DEPARTMENT OF TRANSPORTATION**National Highway Traffic Safety Administration****49 CFR Part 571****[Docket No. NHTSA-03-15343]****RIN 2127-AJ09****Federal Motor Vehicle Safety Standards; Occupant Crash Protection**

ACTION: Correcting amendment.

SUMMARY: This rule corrects errors in Figures 6a, 6b, 7, 8, and 9 of Federal Motor Vehicle Safety Standard No. 208, *Occupant crash protection* (FMVSS No. 208). These figures were added to the standard in two separate and unrelated rulemakings. They provide instructions

Figure 6a. Sun Visor Label Visible when Visor is in Down Position.

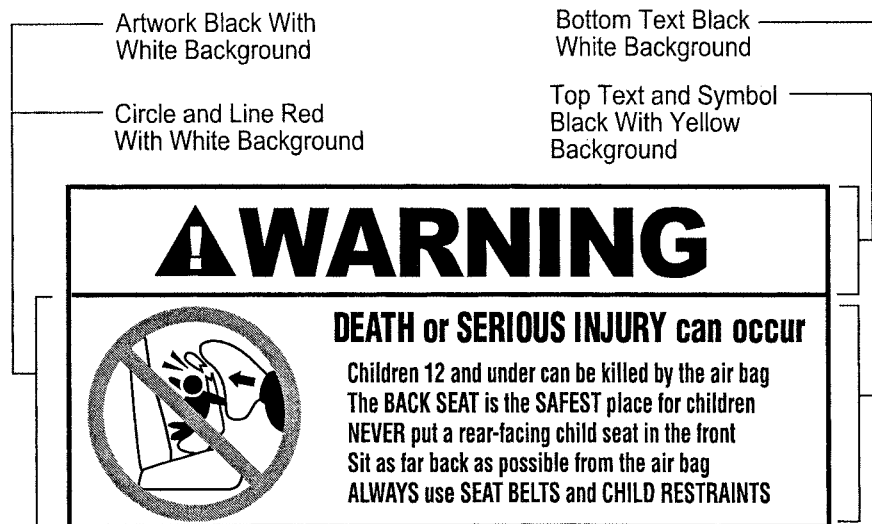
There are two instructions in Figures 6a and 6b and one instruction in Figure 7 that are not restated in any requirements in the regulatory text. One is a format/color instruction about a black outline. The other is a color instruction about using red for bullets in the message area. Figure 7 contains only the format/color instruction about the black outline.

Accordingly, we are amending Figures 6a, 6b and 7 of FMVSS No. 208 to remove the reference to a black outline. We are also amending Figures 6a and 6b to delete the reference to red bullets. We are likewise amending Figures 8 and 9. Figure 8 was based, in large part, on Figures 6a and 6b. Figure 9 was based on Figure 7. When the advance air bag final rule incorporating Figures 8 and 9 was published (65 FR 30680, Docket No. NHTSA-00-7013, May 12, 2000), the agency had already indicated in the earlier rollover label rulemaking that it did not believe the outline in Figures 6a, 6b and 7 were required. The instruction should not have been included in Figures 8 and 9, since we made no findings in that rulemaking that our previous position was incorrect.

■ 2. Section 571.208 is amended by revising Figures 6a, 6b, 7, 8, and 9 to read as follows:
